TECHNICAL INFORMATION

72363
(Page 1 of 2)

Subject	▶ Addition of Front Bumper, Rear Bumper and Hook, Change of Front Wheel Cover Complete, Rear Wheel Cover and Motor Housing Complete
For Models	▶ 2107F, 2107FK
Country	▶ See note below.
Description	▶ See below.

Modification of Front Wheel Cover

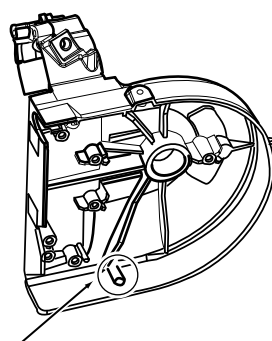
Added: Ribs

Modification of Rear Wheel Cover

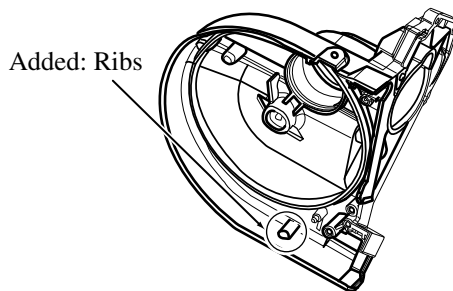
Added: Ribs
